DART SERVICE INSTRUCTION

TO AMEND INSTALLATION INSTRUCTIONS D350-567 REV. E
AND INSTRUCTIONS FOR CONTINUED AIRWORTHINESS ICA-D350-567 REV. 2

REF. TCCA STC: SH92-18

To provide a new location for the cabin fire extinguisher for aircraft equipped with P/N 19810-02-00 (SICMA-198 Seat). For further information on SICMA-198 Seats refer to Airbus CMM 25-12-31.

**DETAIL A**

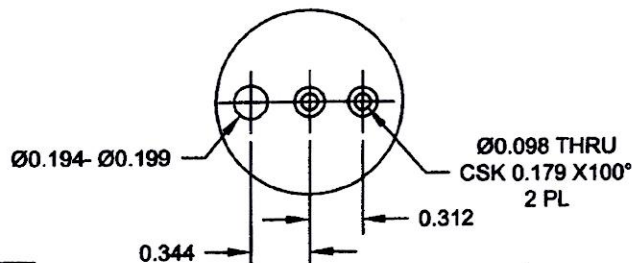
Locate the D5420-1 Doubler Plate at the selected location per Figure 1 and transfer mark the holes from the D5420-1 Doubler Plate to the aircraft floor. Drill the nutplate hole pattern shown in Detail A. Touch up the drilled floor surface finish with chemical film (Alodine 1200/1201) per MIL-C-5541 and one coat of MIL-P-85582 or MIL-P-23377 primer.

FIGURE 1

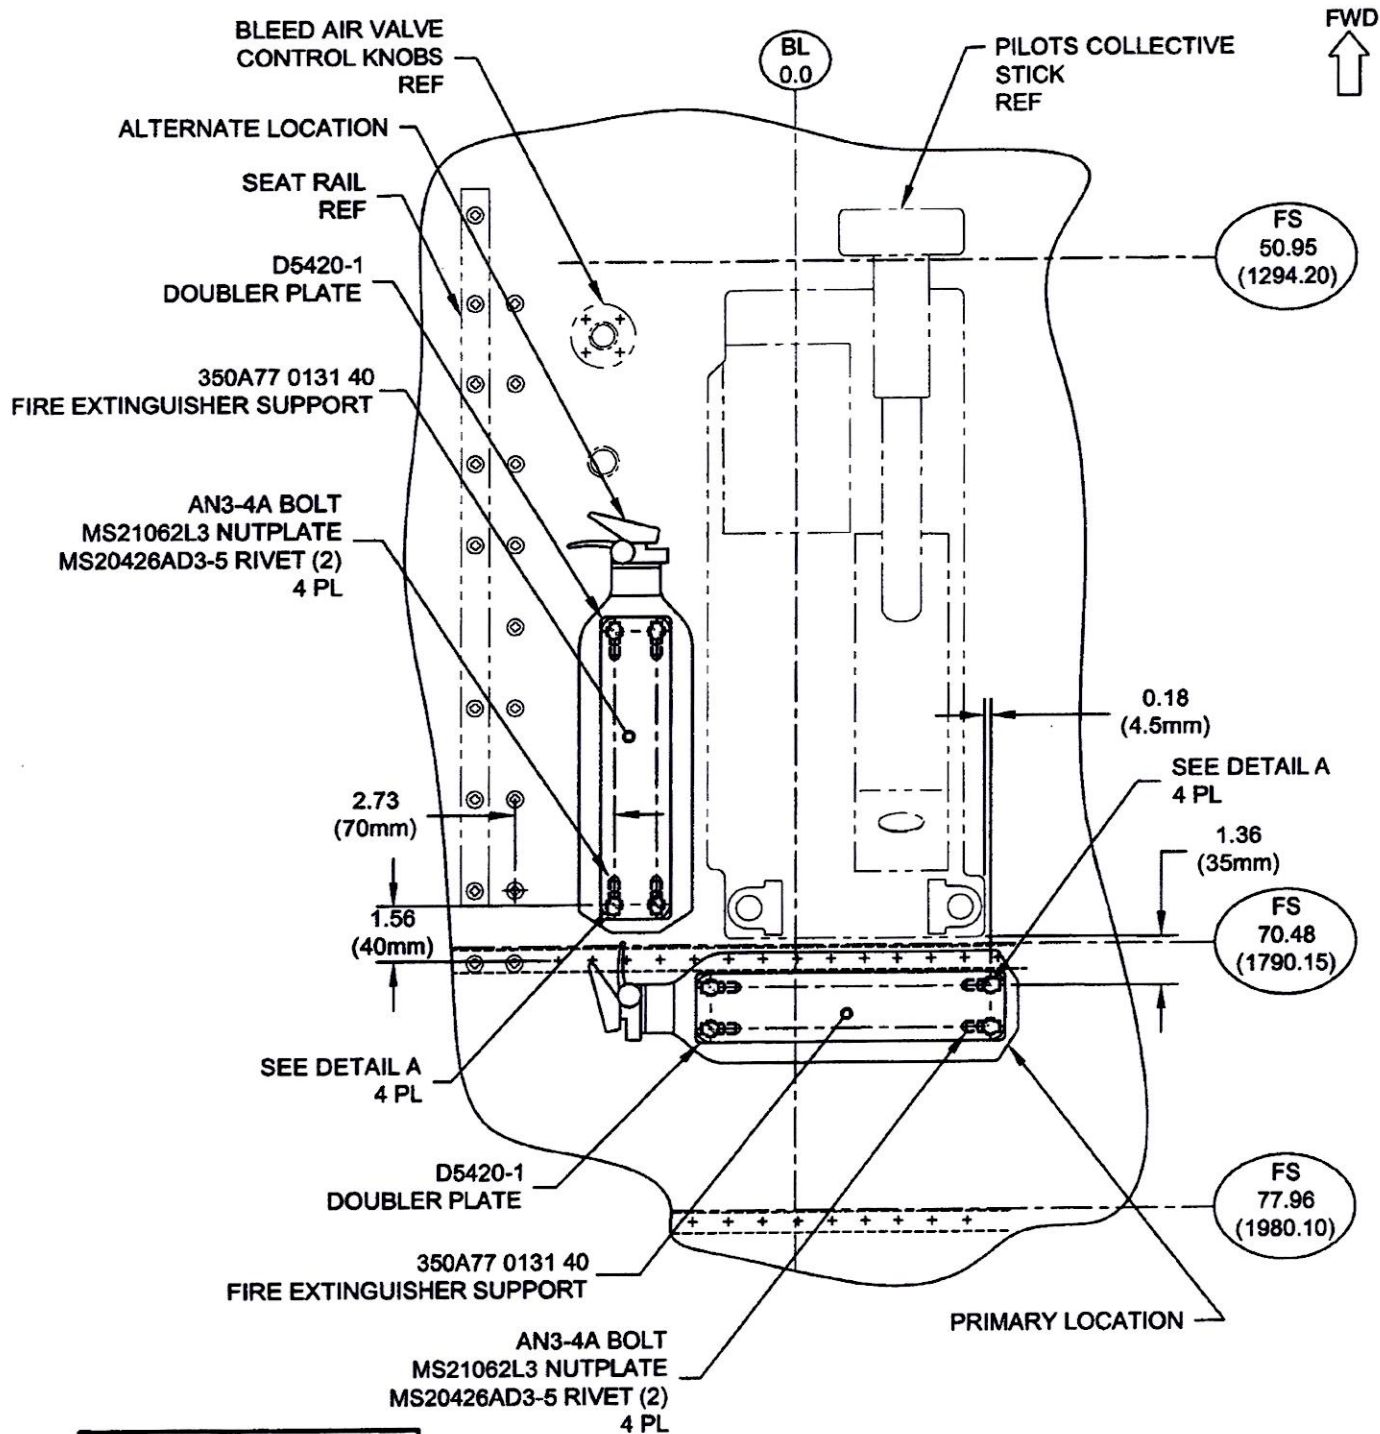
Remove and retain the cabin fire extinguisher P/N 1708337 B4 and Fire Extinguisher Support P/N 350A77 0131 40 from existing location. Per Figure 1, select the desired location for the fire extinguisher at either the "Primary" location or "Alternate" location.
